Review of two flood mitigation projects: Bragg Creek / Springbank off-stream flood storage and McLean Creek flood storage

Review of two flood mitigation projects: Bragg Creek / Springbank off-stream flood storage and McLean Creek flood storage

Figure 2 Location and reservoir area of the Springbank off-stream storage project (SR1)

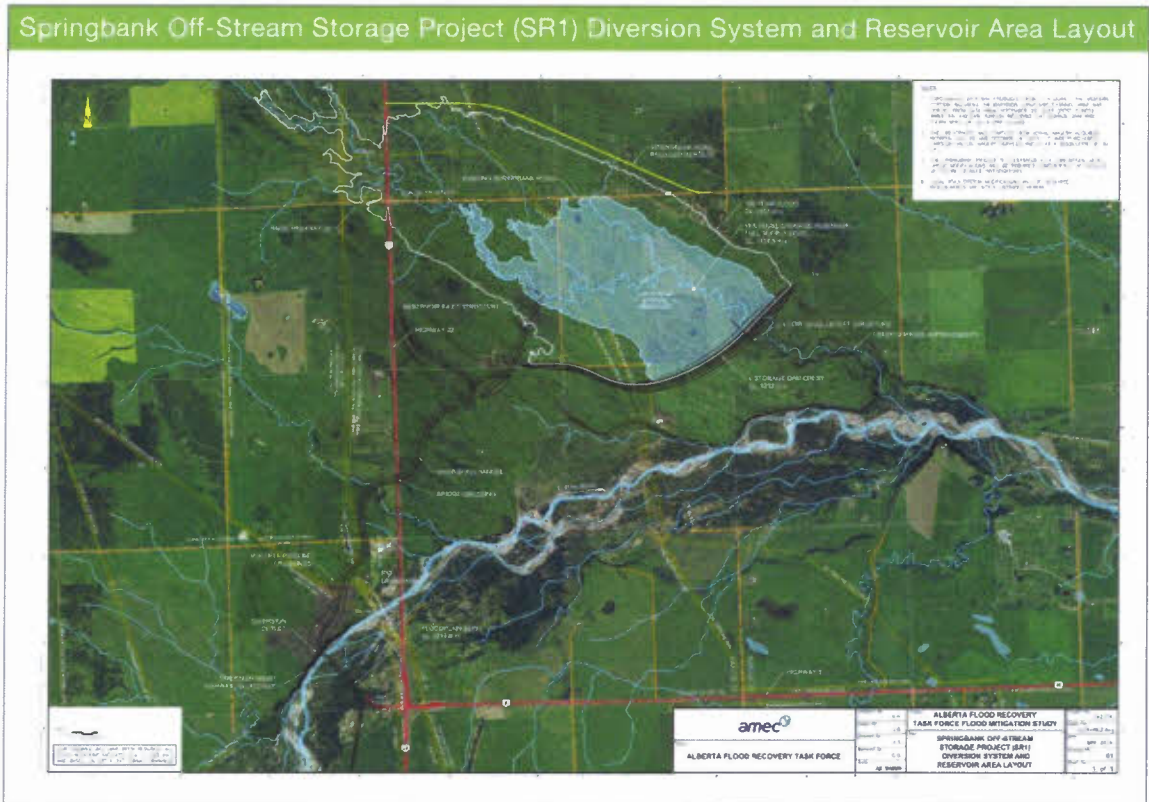
The Springbank off-stream storage (SR1) site is located just west of Calgary approximately 18.5 km upstream of the Glenmore Reservoir in a relatively undeveloped farmland and ranchland valley. According to the concept prepared by AMEC (2014b), the SR1 concept involves diverting extreme flood flow from the Elbow River into an off-stream storage reservoir where it would be temporarily contained and later released back into the Elbow River after the flood peak has passed.

The diversion structure would consist of a concrete overflow weir section crossing the Elbow River, a gated concrete sluiceway/fishway located on the left valley abutment with its invert at the river thalweg level, and another gated diversion outlet structure located in the left valley abutment immediately upstream of the sluiceway.

The diversion weir component of the diversion structure is a 100 m long concrete structure with an ogee crest shape and a hydraulic jump stilling basin. This structure serves to reduce approach velocities and increase the river water level to facilitate diversion through the outlet structure into the diversion channel.

The outlet structure invert level would be located approximately 1.5 m above the river thalweg in order to prevent that larger bottom sediment enters the diversion channel.

The diversion channel was originally designed to convey a peak diversion flow of 300 m³/s¹ from the Elbow River into the off-stream storage reservoir. The channel is designed with a 24 m bottom width three horizontal to one vertical side slopes and a 3.6 m water depth.

A 3 km long earth-fill storage dam, having a maximum height of 24 m, is required to contain the diverted flood water. The dam system will include a gated low-level outlet structure. The structure will include a 1.5 m wide by 1.8 m high concrete conduit through the dam, including a gatewell tower located near the dam centerline. This structure will be used to release stored water back into the river after the flood has passed.

¹ In the Stantec adjusted design (April 2015) this seems to be removed, only a 40 m wide spillway/sluiceway in the river bed is assumed. Also Stantec adjusted the diversion channel capacity to 600 m³/s, with design 6.4 m water depth. Also the storage dam is a bit higher and a few 100 m downstream. Same intake location from the river, and same outlet structure at the dam
